S/D No.: 86-17      Name: NOORDHOEK ADDITION

Re: S/D 86-17 - Final Plat of Noordhoek Addition.

**FINAL PLAT**

**NOORDHOEK ADDITION**

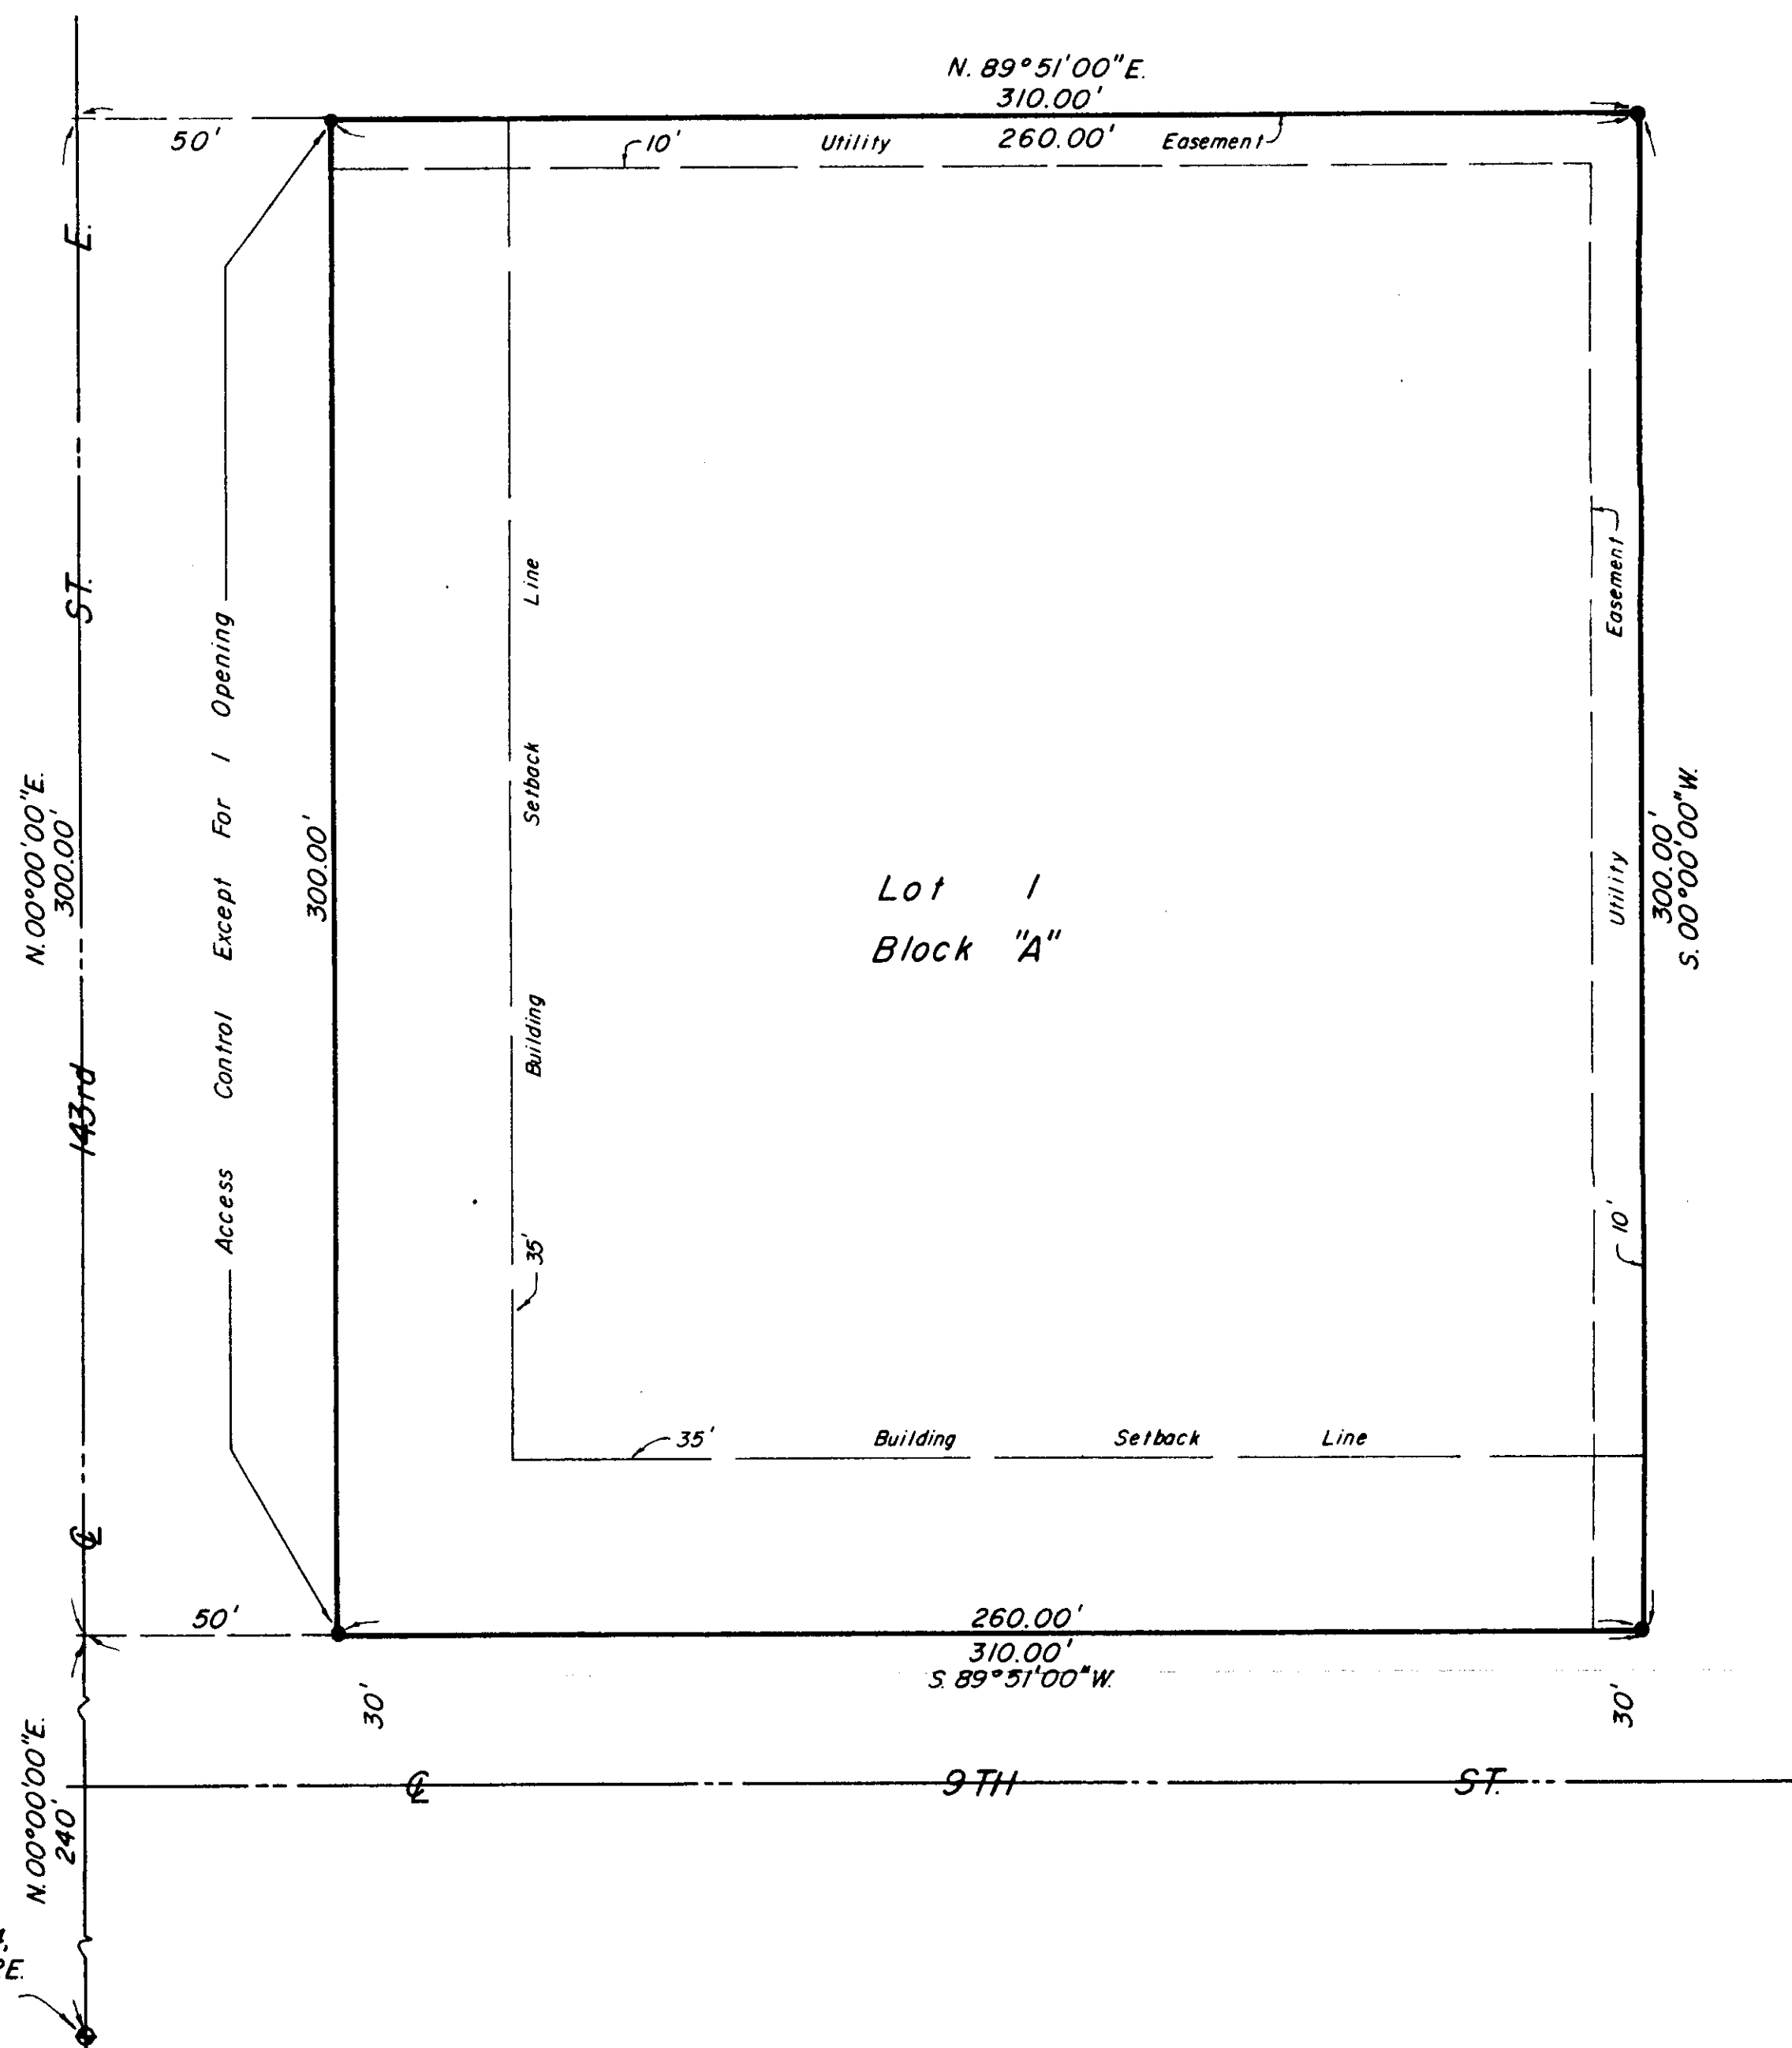
- A. The applicant shall guarantee the extension of sanitary sewer to serve the lots being platted.
- B. If improvements are guaranteed by petition, a notarized certificate listing the petitions shall be submitted to the Planning Department for recording.

- C. Since this property will utilize a City of Wichita water supply line in 143rd Street East, the applicant shall submit an outside-the-City water service application and associated restrictive covenant.

- D. Since this property is located within the 3-mile ring of the City of Wichita, the final plat tracing shall include the City Commissioners' signature block.

- E. The final plat tracing shall indicate a notary block for the signature of the Chairman of the Board of County Commissioners.
- F. On the final plat tracing, the wording in the plat's text, regarding access control, shall be amended to reference that the one permitted opening to 143rd Street shall be determined "by the appropriate engineer."

- G. The applicant shall obtain, by separate instrument, the off-site utility easement needed for the extension of sanitary sewer.
- H. Perimeter closure computations shall be submitted with the final plat tracing. Section 5-101(C).

- I. Recording of the plat within 30 days after approval by the Board of City Commissioners.
- J. The representative from County Engineering should be prepared to comment on the status of the applicant's drainage plan.

*Need City oppr block*

*Notary Block*
